Rezoning Request – The Central District (Extension) Outline Zoning Plan No. S/H24/6

Proposals to Amend the Outline Zoning Plan to Reduce the Amount of Reclamation, Reduce the Amount of Commercial Development and Reduce the Extent of Roads

Volume 1
Planning Statement

保護海港協會有限公司
Society For Protection Of The Harbour Ltd

FIGURE 1 The Central District (Extension) Outline Zoning Plan No. S/H24/6 Showing the Extent of the CR III Reclamation

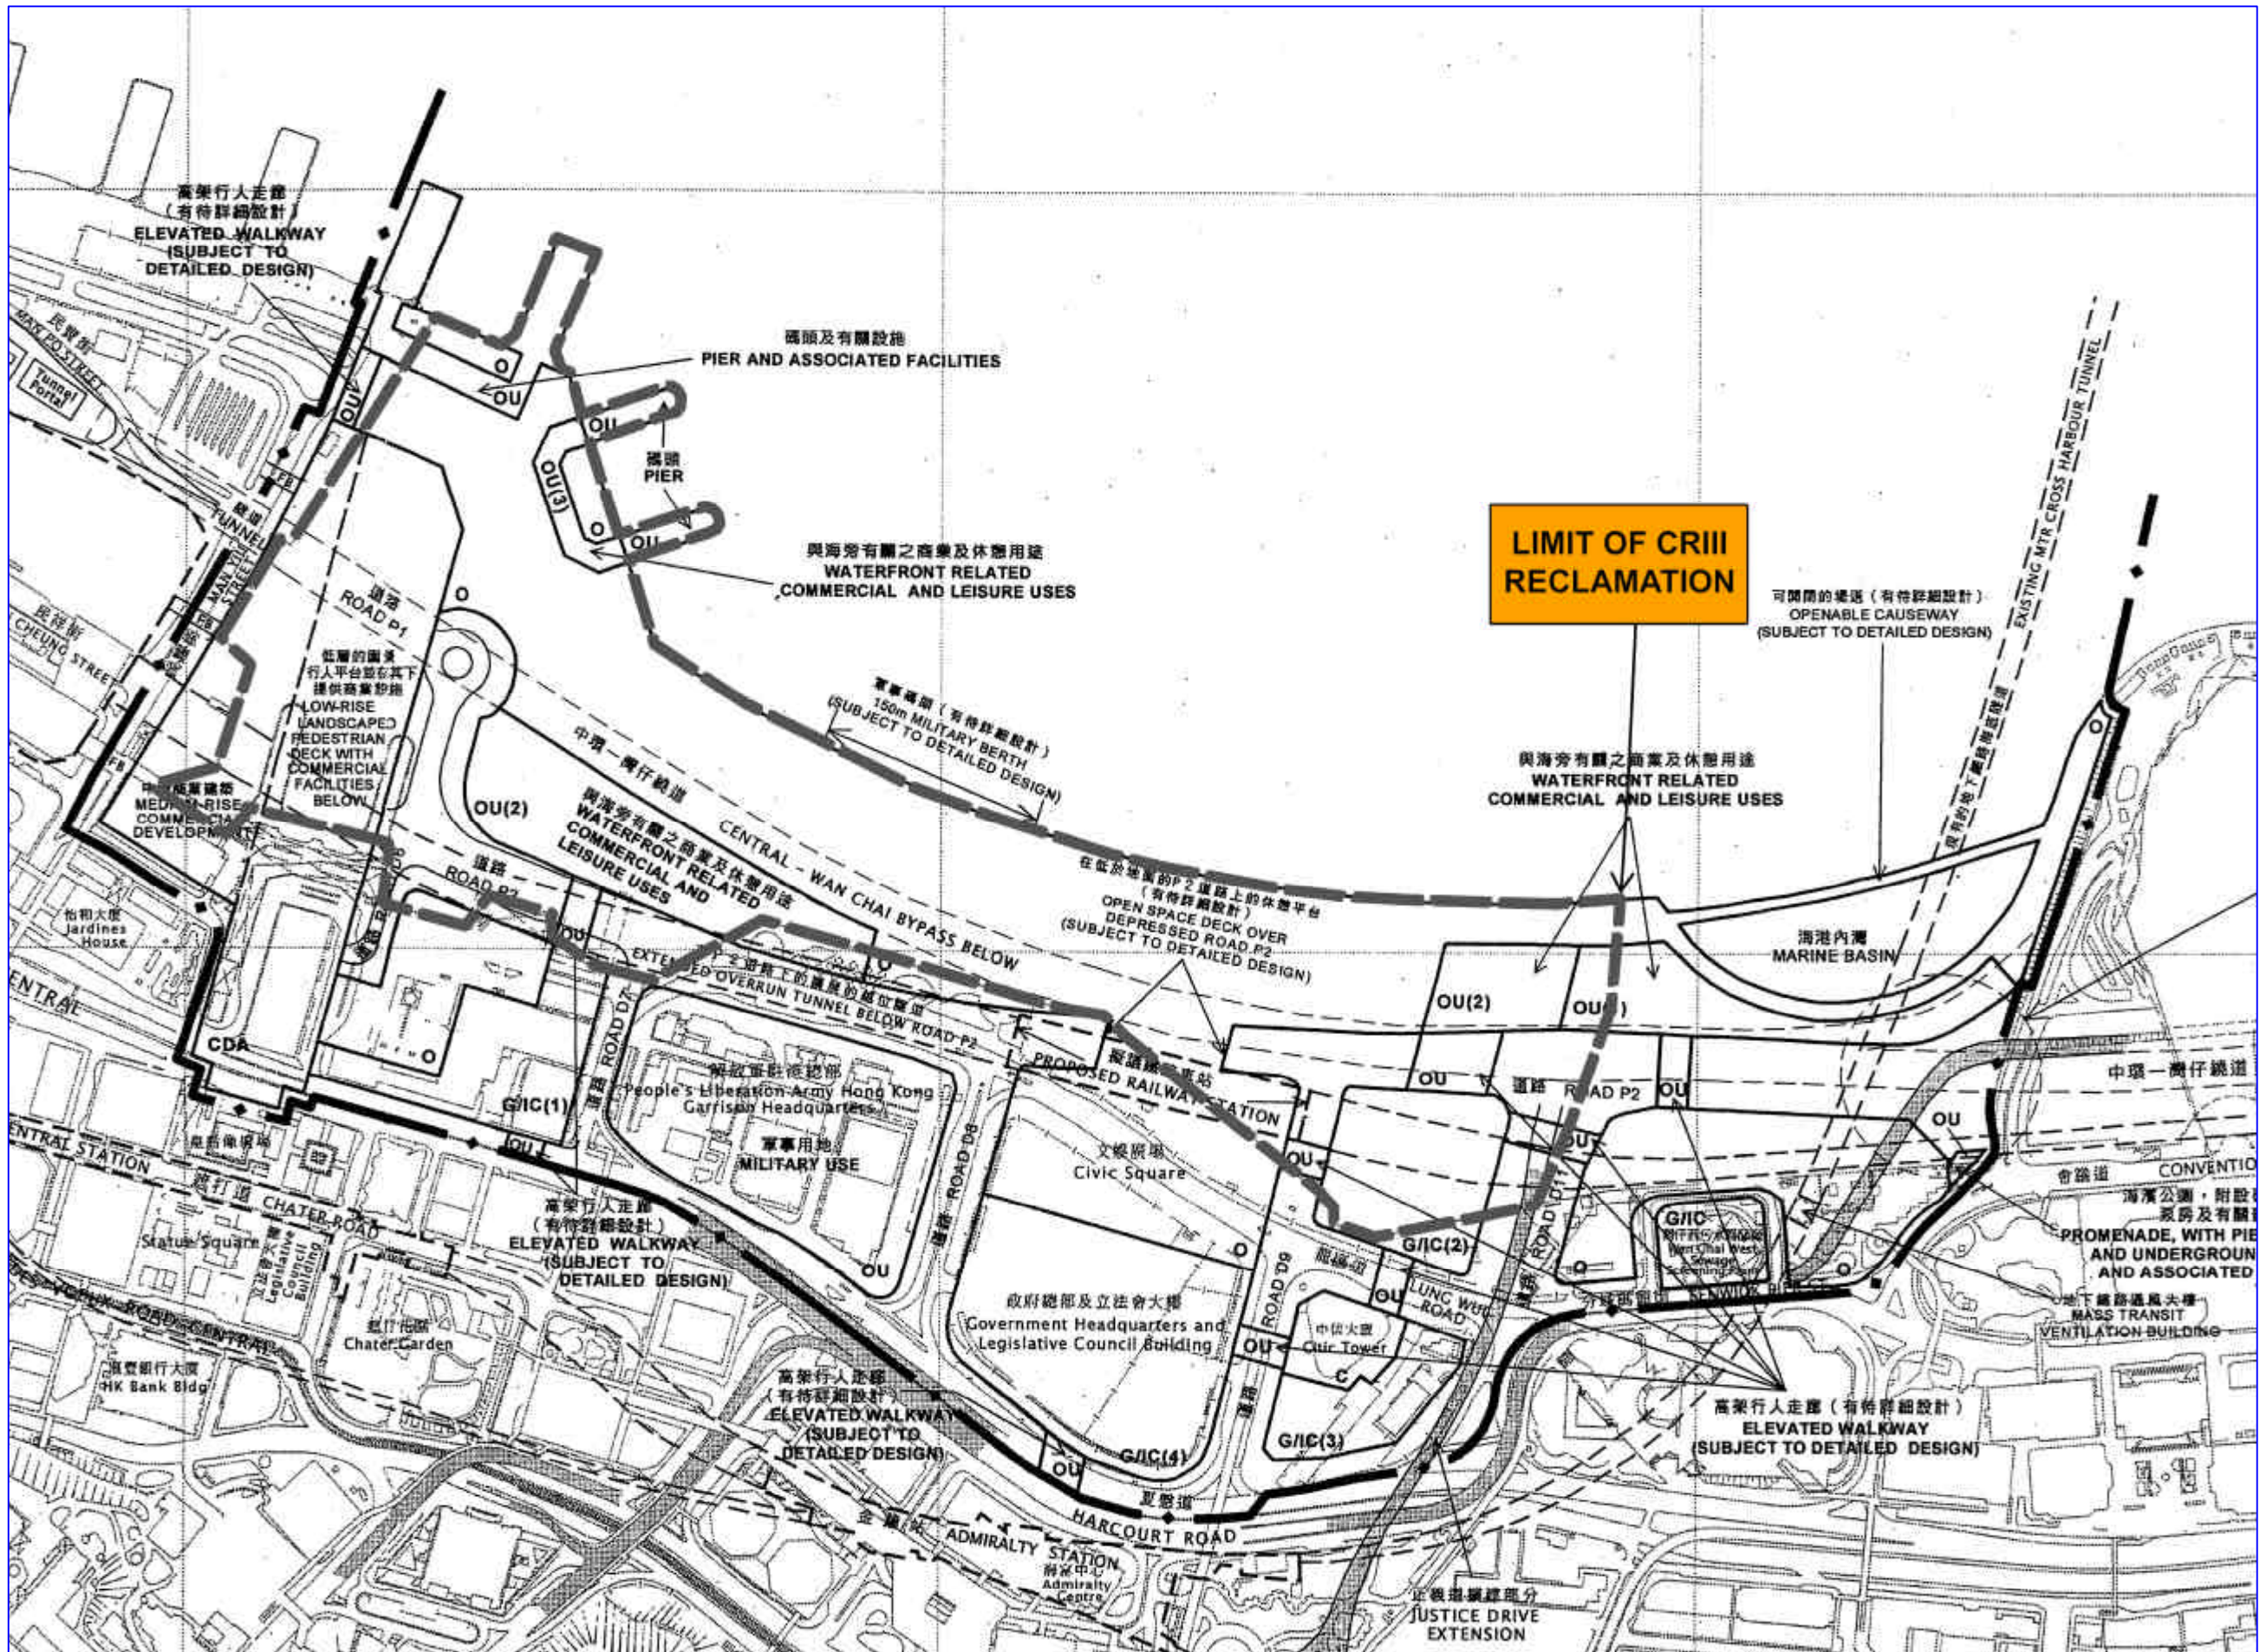
4.2.1 Figure 1 is an extract from the Central District (Extension) Outline Zoning Plan and it indicates the extent of the reclamation which is included within the CR III engineering contract. Only this portion of the plan was included in the Government Review. Within the CR III area the construction of Pier 8 is well advanced and it will provide for the reprovisioning of the Star Ferry Pier. For the purpose of this submission it will be assumed that Pier 8 is fixed and the alignment of the seawall on the western portion is therefore also fixed in a line from Pier 8 south-eastward.

4.3.1 To the east of the CR III contract boundary is an area of proposed reclamation which has not been committed for construction (see Figure 1). This includes areas zoned for "Waterfront Related Commercial and Leisure Uses", "Open Space", a "Marine Basin" and for Roads P2 and D11.

4.3.2 This area was excluded from the Government Review as it is outside the contract limits for CR III. **The extent and justification for the amount of reclamation within this area has therefore never been assessed in terms of the CFA Judgement.** It would also appear unlikely to be assessed as part of the Board's review of the Wan Chai North Outline Zoning Plan as it is not located within that plan. It is therefore essential that the Board takes this opportunity to review the proposals within this easterly portion of the plan and to delete those parts which cannot meet the "over-riding public need" test.

FIGURE 7 Drawing extracted from Government Review indicating Cooling Water Pumping Stations and “Red Areas” of Unjustified Reclamations

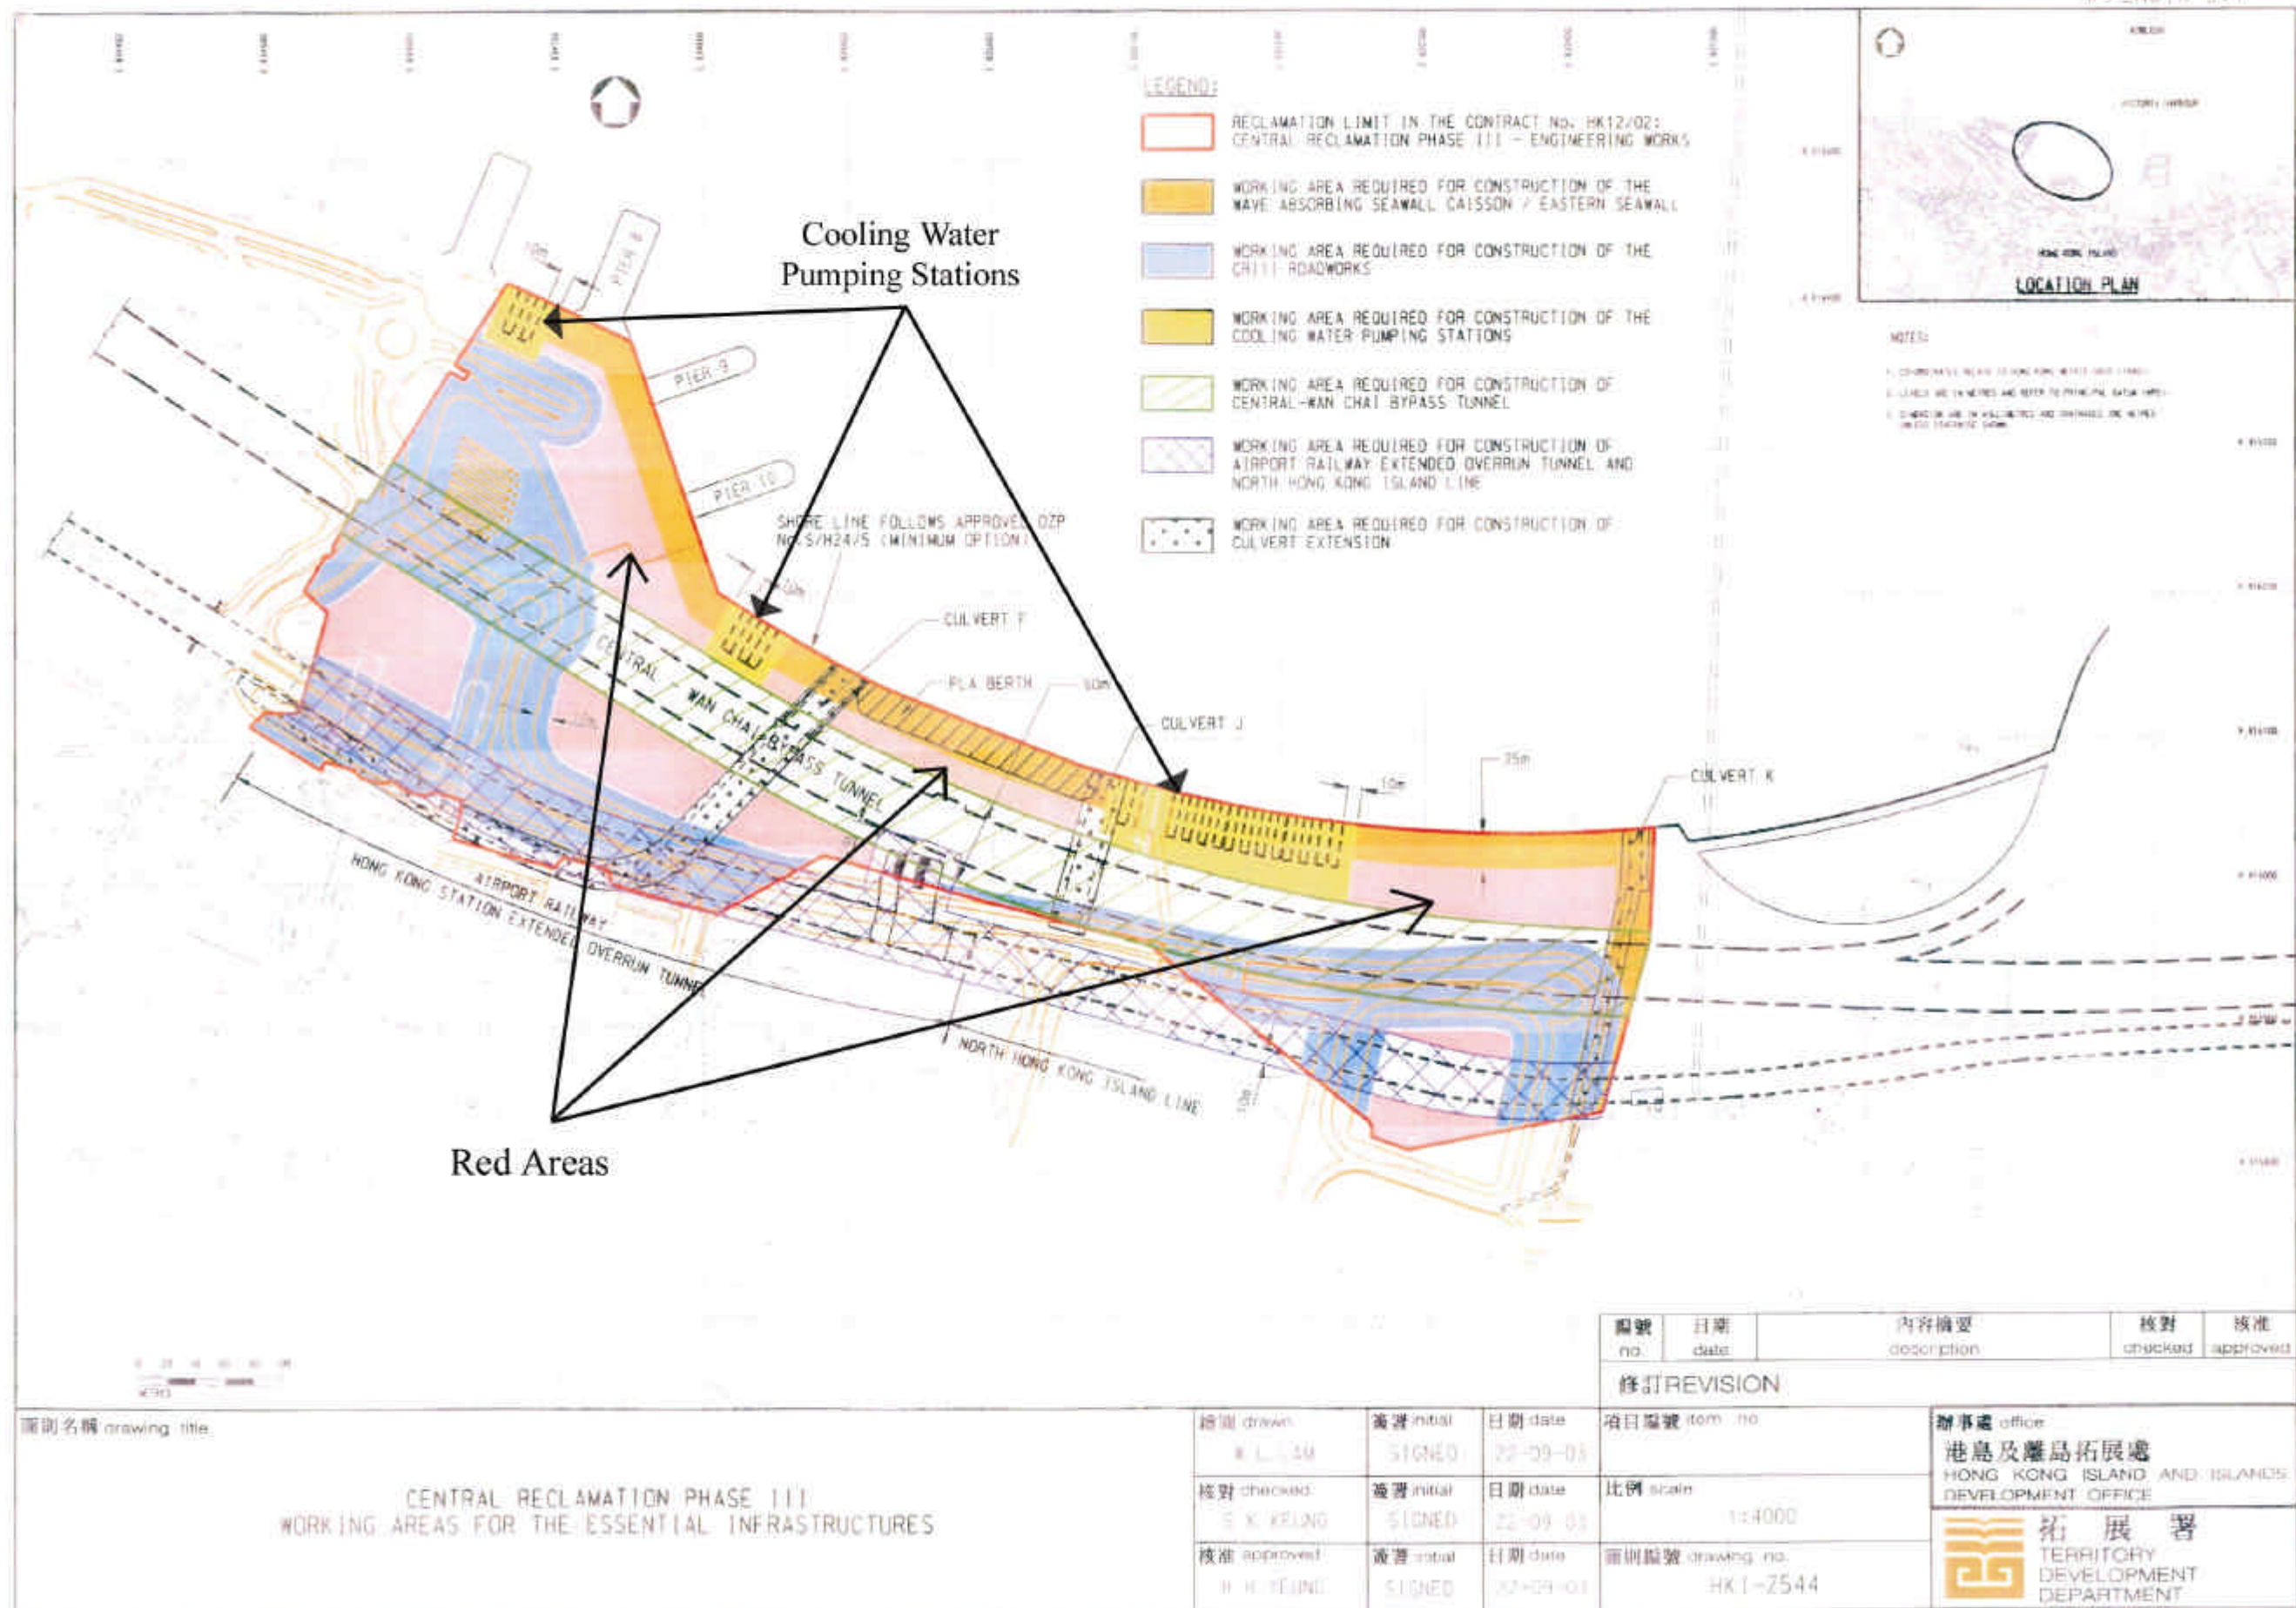
4.6.3 The proposals regarding pumping stations set out in the Government Review (See Figure 7) do not show an earnest effort to minimize reclamation. If such an effort had been made, it was inadequate and failed to comply with the CFA Judgment as insufficient measures were taken to protect and preserve the Harbour. Various alternatives have been investigated in Appendix 1, which could substantially reduce the extent of reclamation needed, either to provide the proposed pumping stations or to use a different system to achieve the same purpose. There are no major insurmountable

4.7.1 In the Review there were areas identified as "Red Areas". (See Figure 7). In effect these were areas of reclamation which could not be justified in their own right. They fell between the adopted alignment of the sea wall and the CWB. The Review argued that these areas could not be left un-reclaimed as they would become stagnant areas of water. This is incorrect as the opportunity existed for the sea wall to be realigned closer to the CWB, thus eliminating the "Red Areas". These areas of reclamation have not been justified but will be reclaimed so as to allow for the adopted alignment of the sea wall to be built. The Review clearly identified areas of reclamation which continue to fail to meet the CFA test and should not be reclaimed.
